Application No : 154764

Lot 308 Subdivision

Site Inspection 4 July 2019

D Nielsen and W Sanderson Shire of Carnarvon

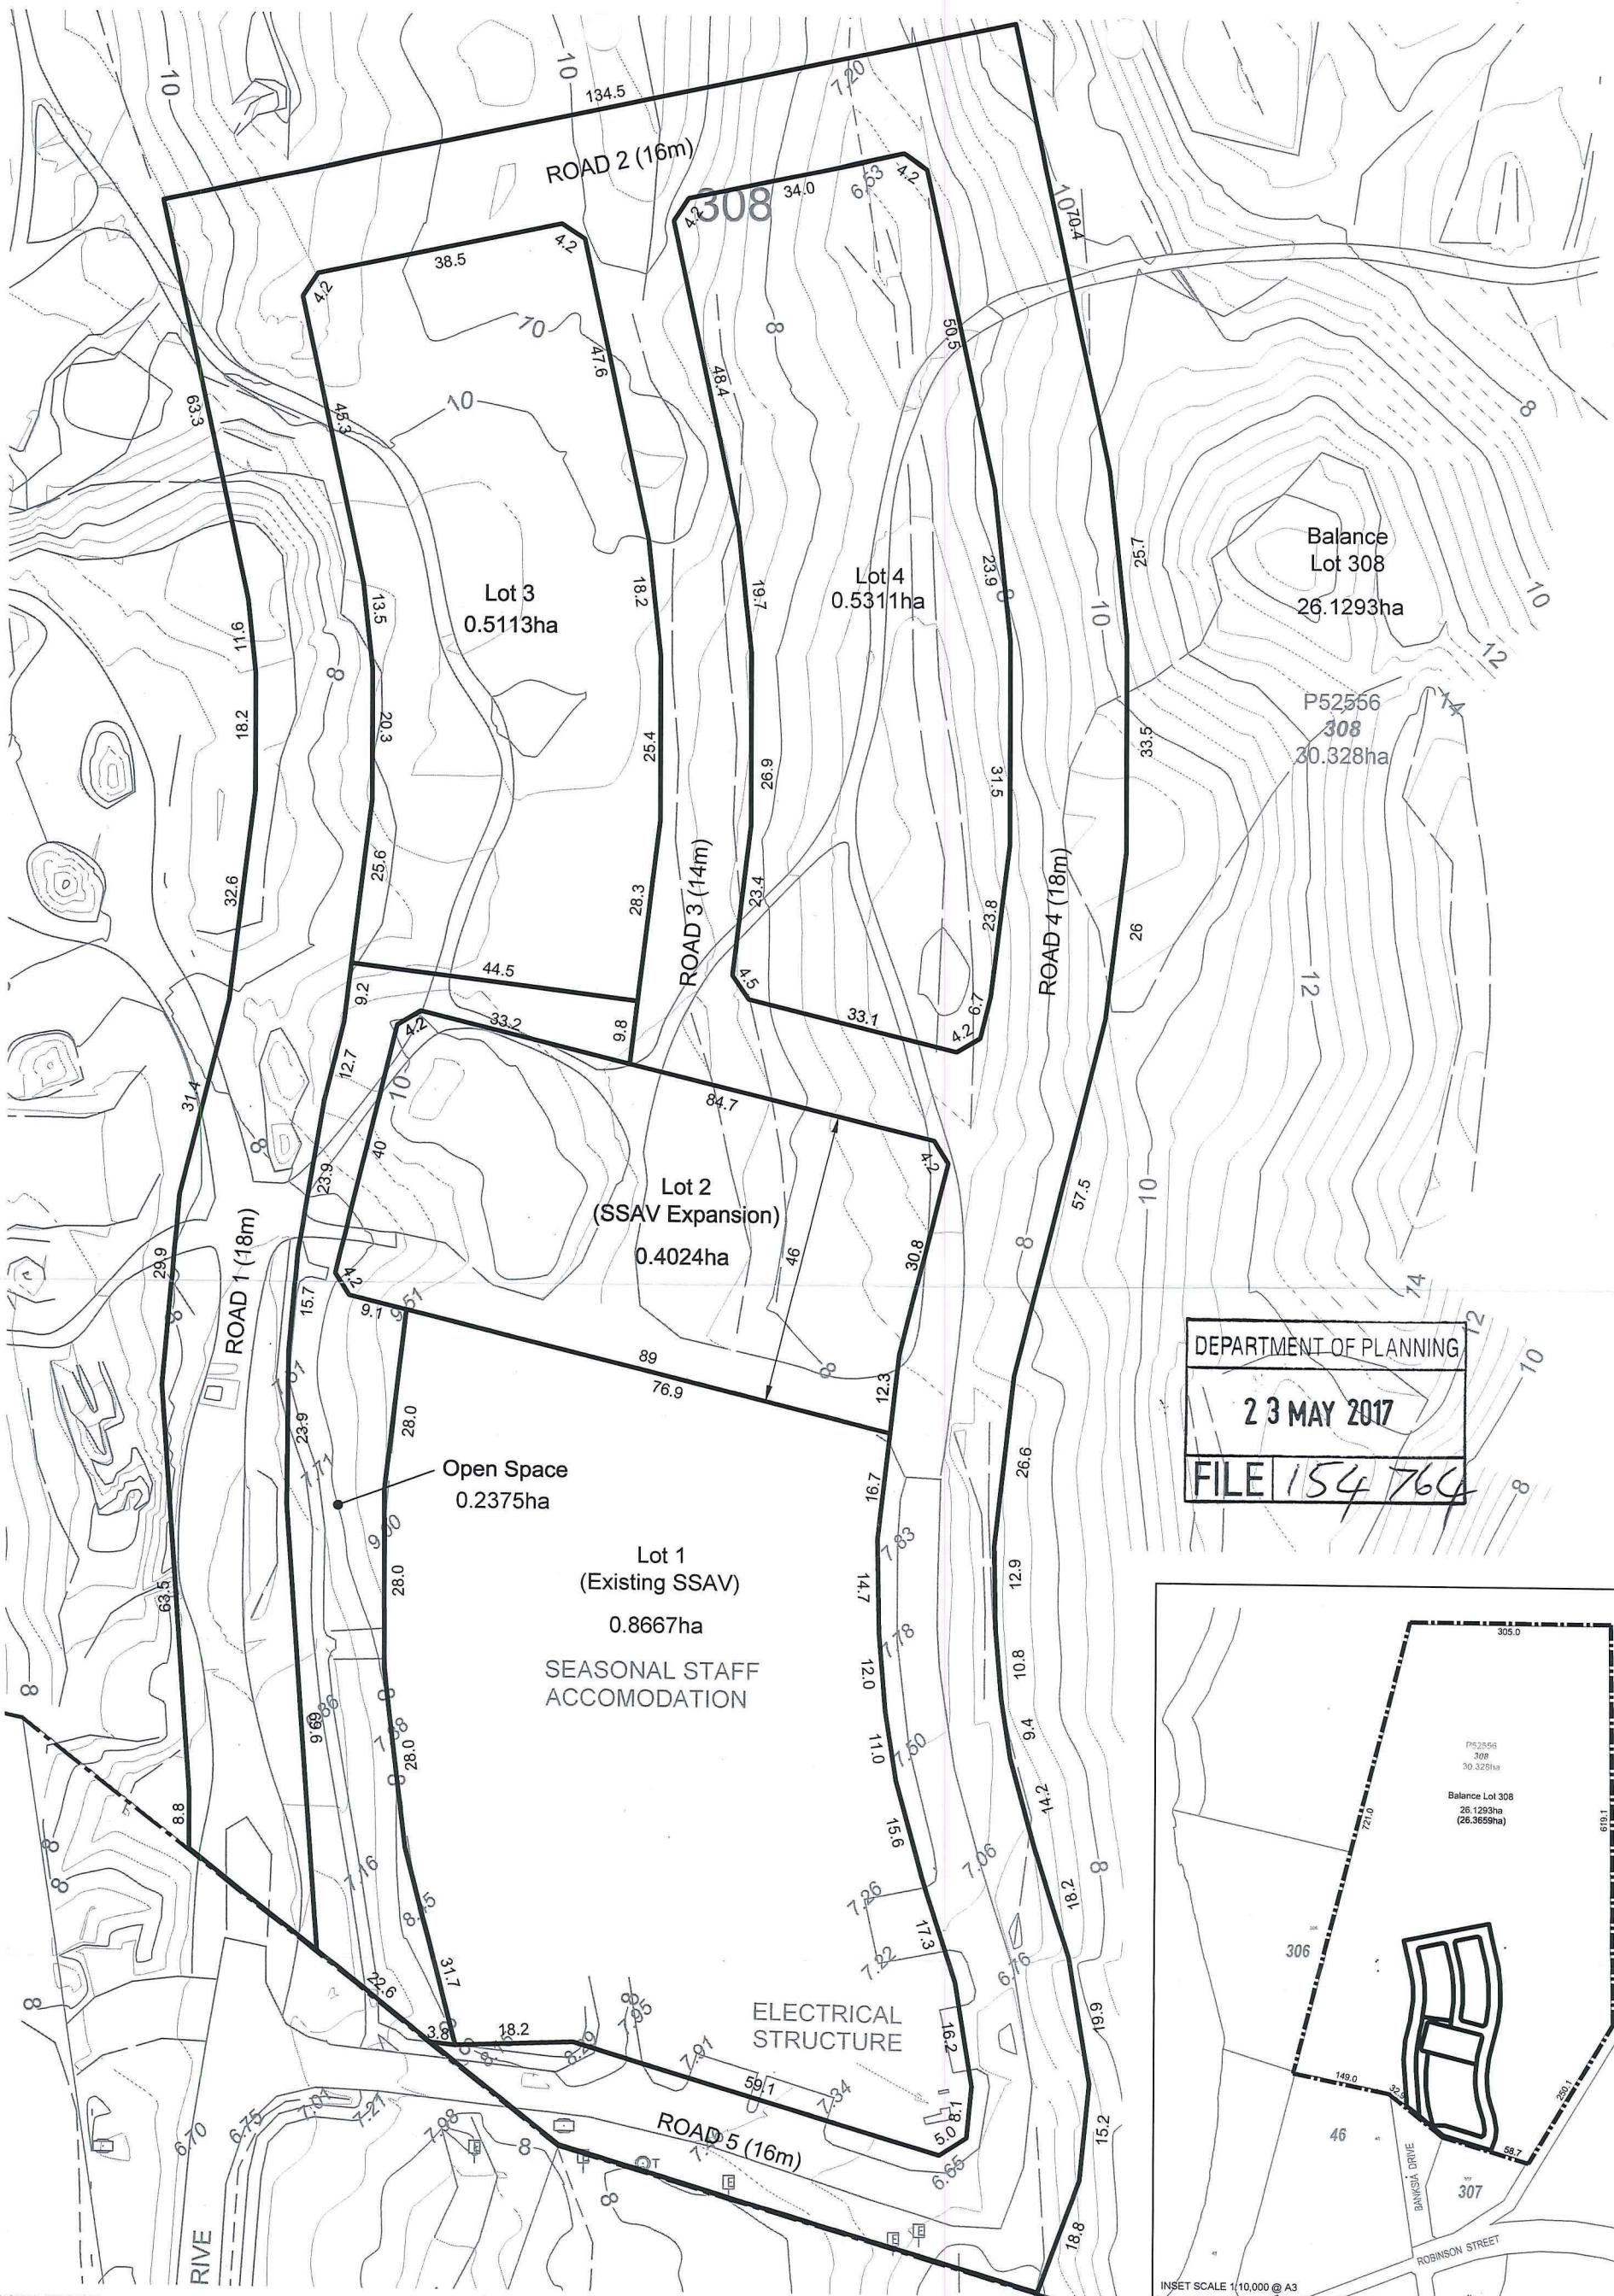
1. The plan of subdivision is to be modified (marked 'X') as per the plan dated 27 January 2017 (attached) as follows:
 - Lots 3 and 4 to be amalgamated to be one lot and proposed Lot 2 is to be a minimum lot size of 4000m². (Local Government)
2. Engineering drawings and specifications are to be submitted, approved, and subdivisional works undertaken in accordance with the approved plan of subdivision, engineering drawings and specifications, to ensure that those lots not fronting an existing road are provided with frontage to a constructed road(s) connected by a constructed road(s) to the local road system and such road(s) are constructed and drained at the landowner/applicant's cost.

1. Condition 1 has been imposed to align the lots with the minimum lot size requirement of the *Coral Bay Settlement Structure Plan 2014* (CBSSP).
2. In relation to Condition 4, the pedestrian network is to be constructed to the satisfaction of the local government, applicable to the context of Coral Bay.

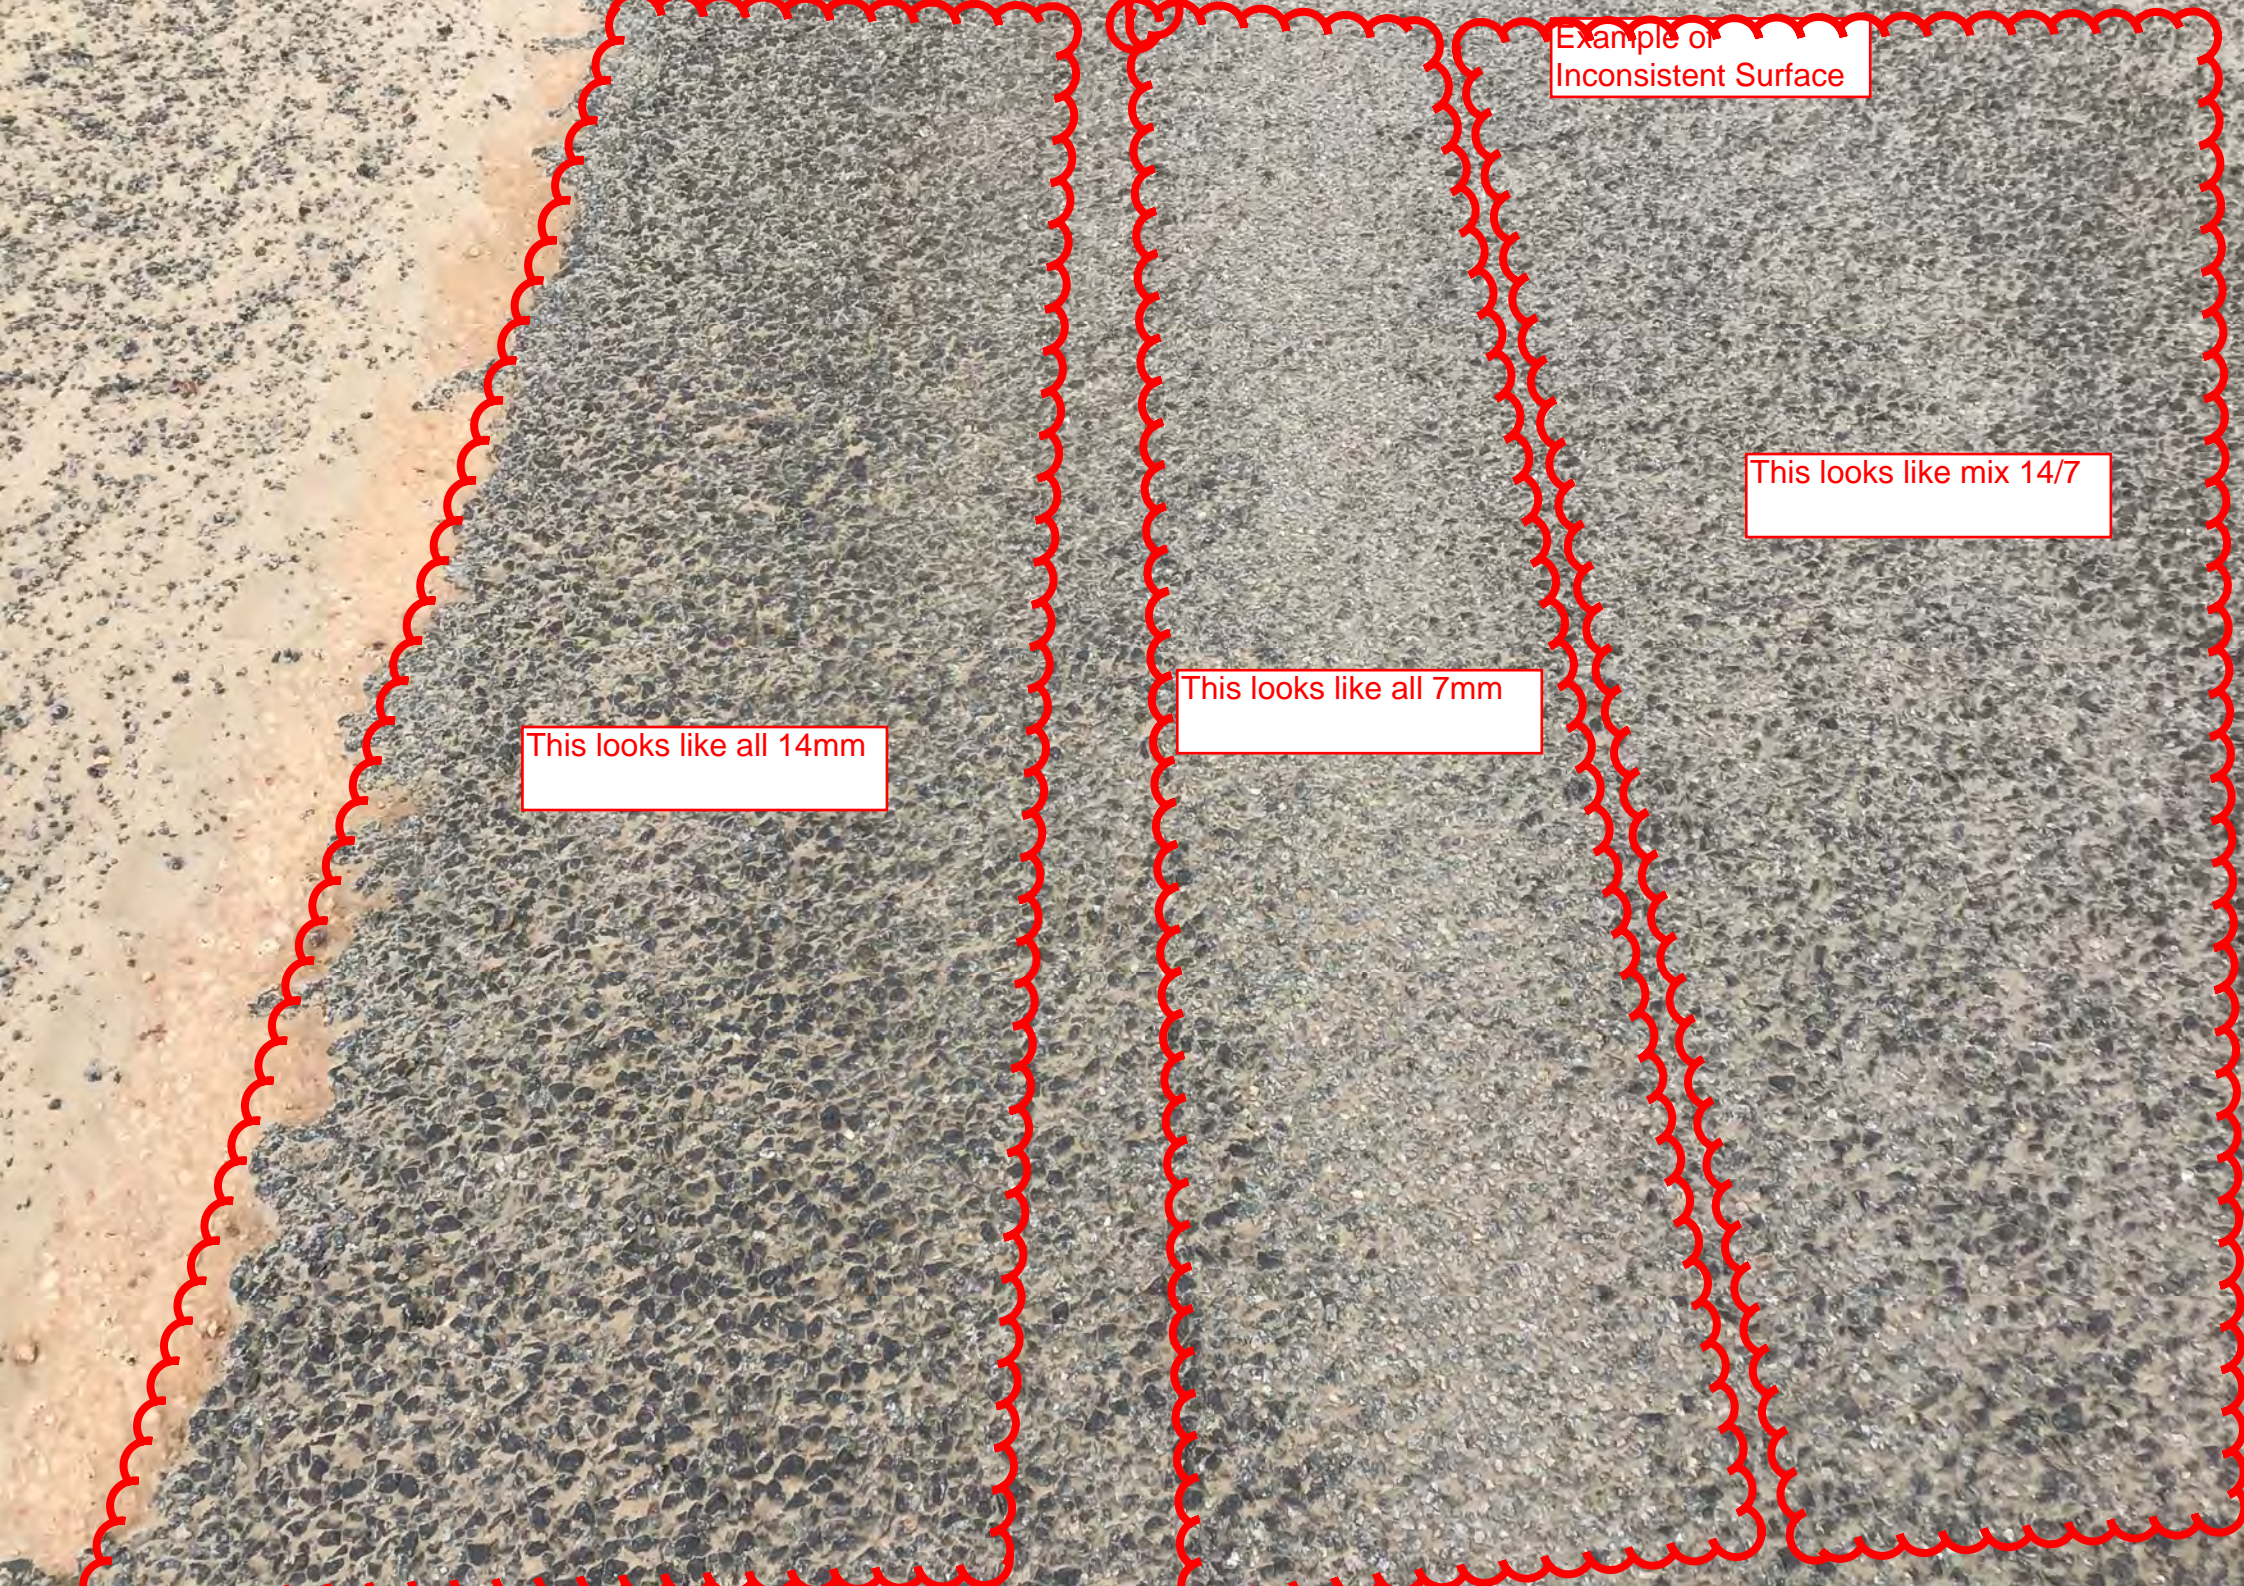
Point Failures in the Seal

- Multiple locations were noted where no aggregate or seal was present on the pavement.
- Identification of these locations requires careful and close inspection of the seal surface and the aggregate matrix.

Cul De Sac Heads

- Multiple seal failures areas were noted on the single coat seal areas in the cul de sac heads.
- The pavement surface finish levels in these areas is also uneven.
- It is acknowledged that these cul de sac areas are likely to require reconstruction as additional subdivision stages proceed. However, there is no guarantee whatsoever regarding future staging timeframes and the level of seal damage already present creates an unacceptable maintenance liability for the Shire.

Western Road Cul de Sac -
Multiple stripped areas

Eastern Road Cul de Sac -
Multiple stripped areas

Eastern Road Cul de Sac -
Multiple stripped areas

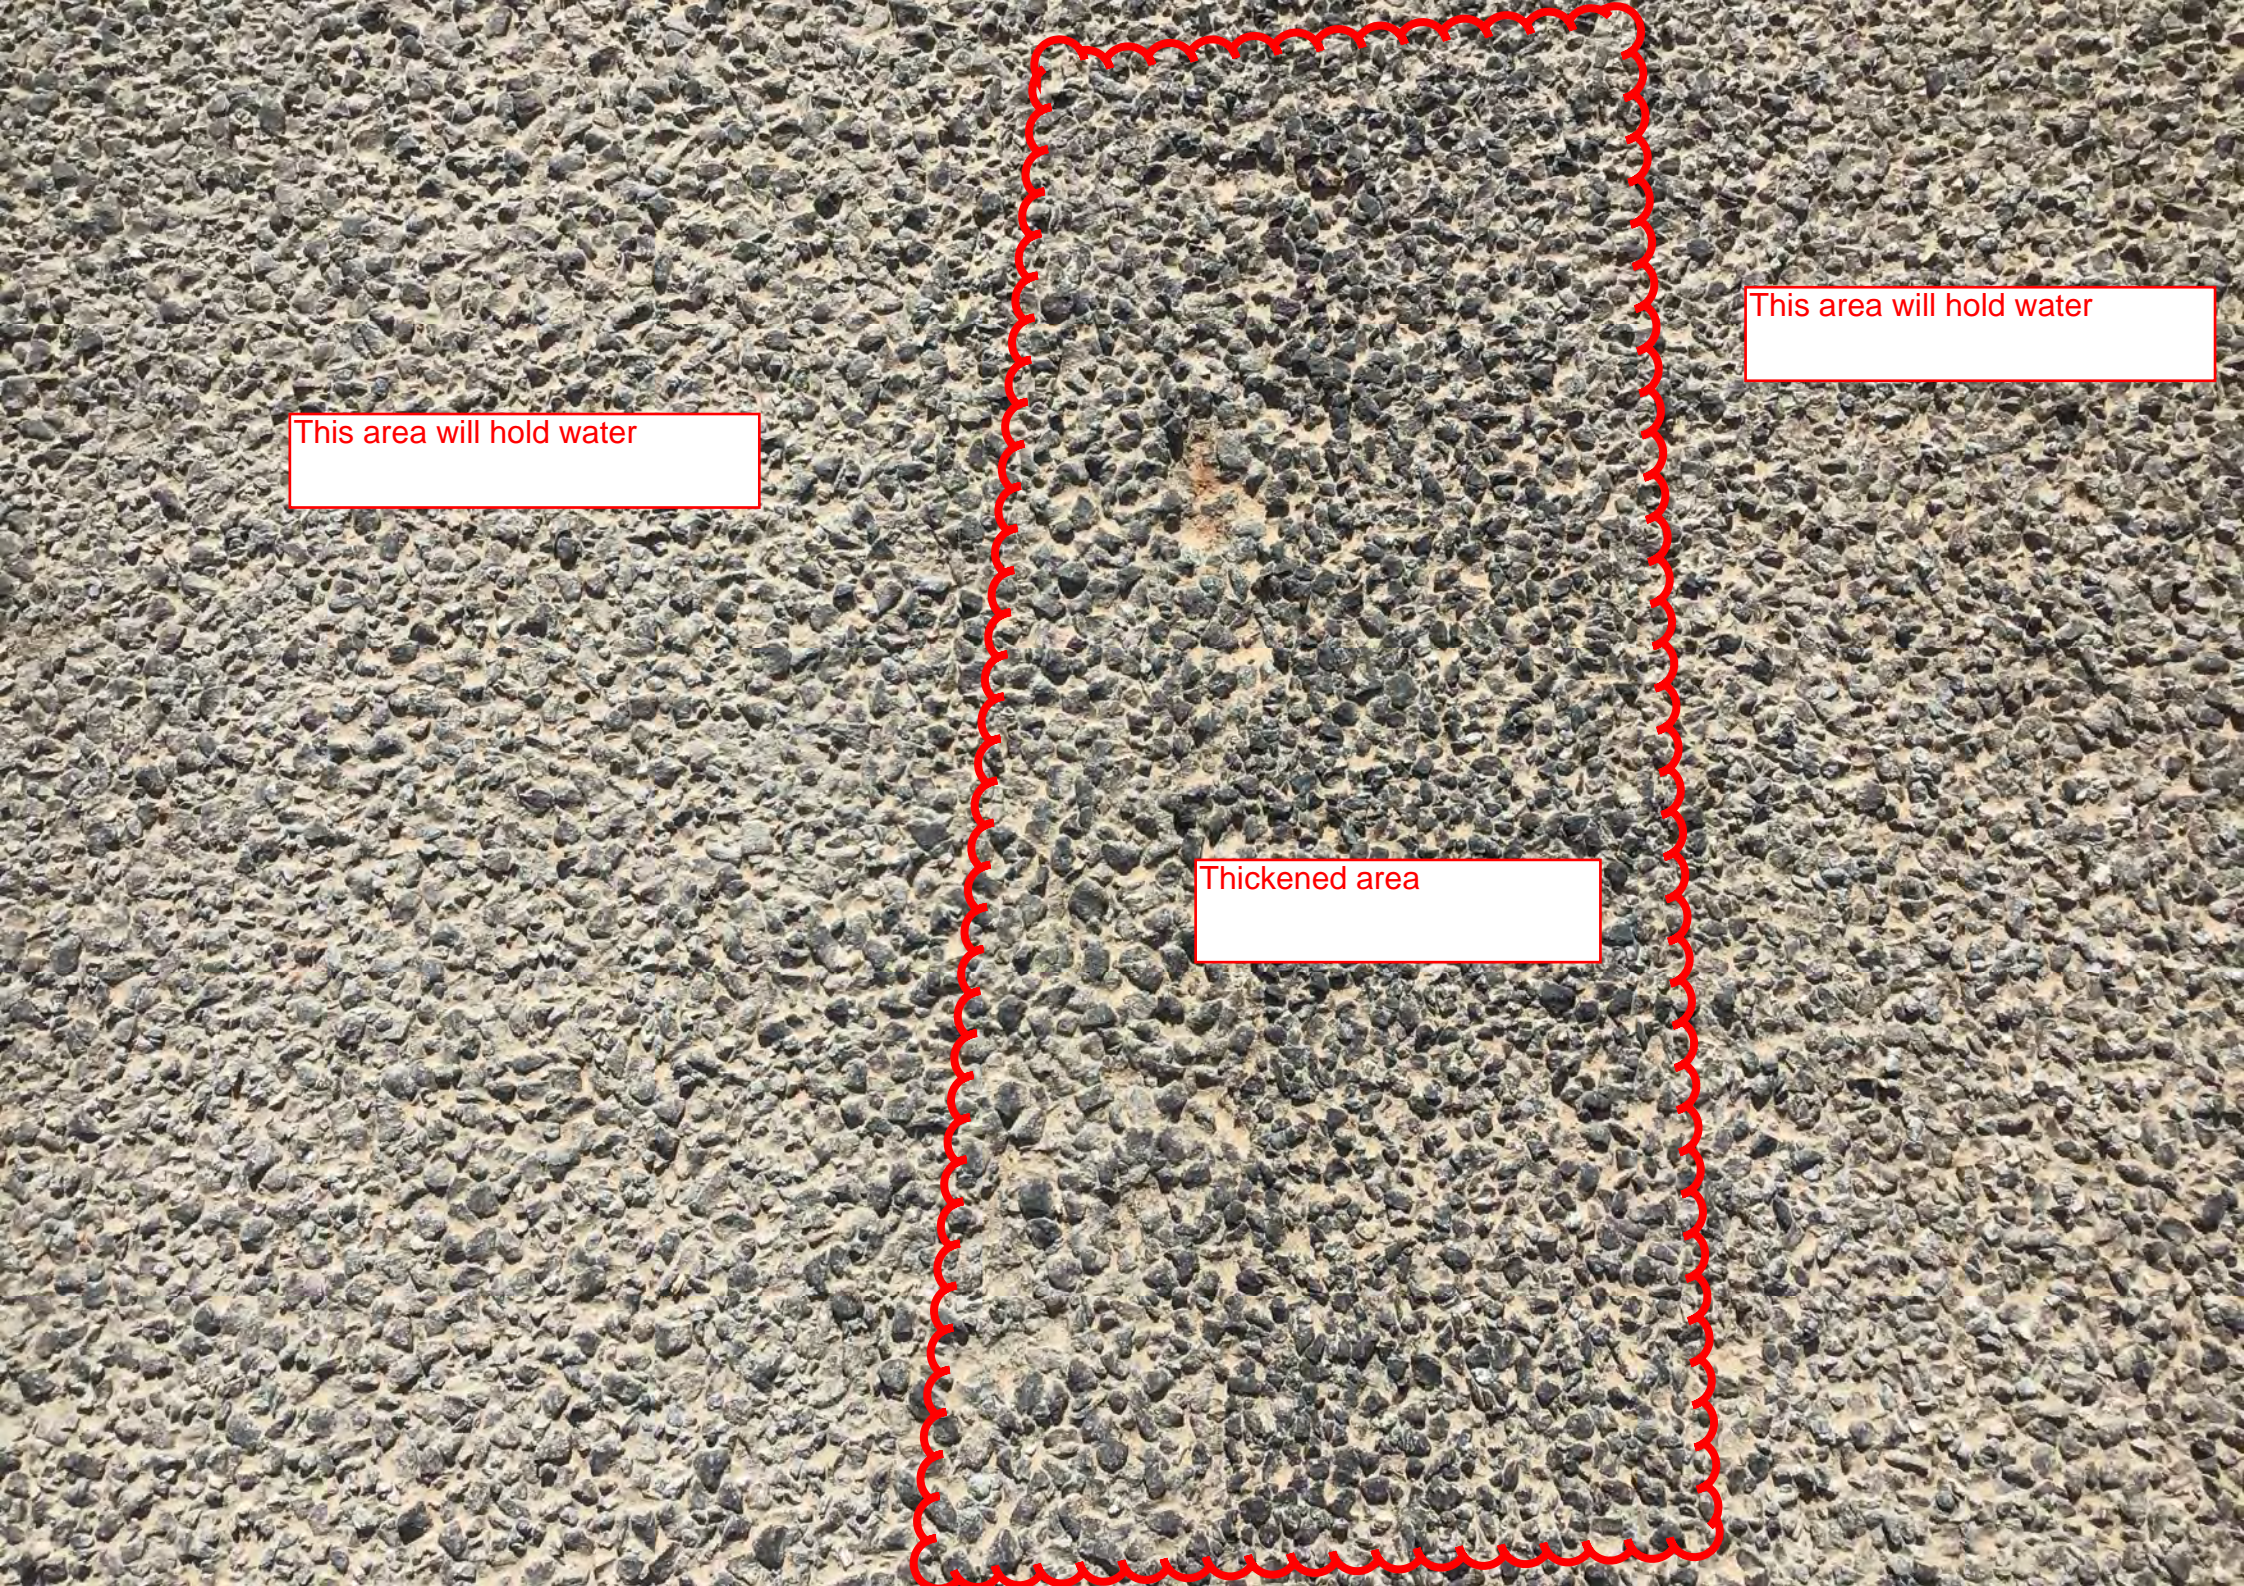
Point Failures

Point Failures

Example of
Inconsistent Surface

This looks like mix 14/7

This looks like all 7mm

This looks like all 14mm

Failure and inconsistent surface

Multiple point Failures in approx 1sqm

Point Failure

Point Failures

Point Failure Close
View

Eastern Road Cul de Sac -
Multiple stripped areas

Eastern Road Cul de Sac -
Multiple stripped areas

Western Road Cul de Sac -
Multiple stripped areas

Looks like a reasonable aggregate matrix
but again - a point failure

Edge Breaks

Edge Breaks

Edge Breaks

Edge Break and Thickened
area
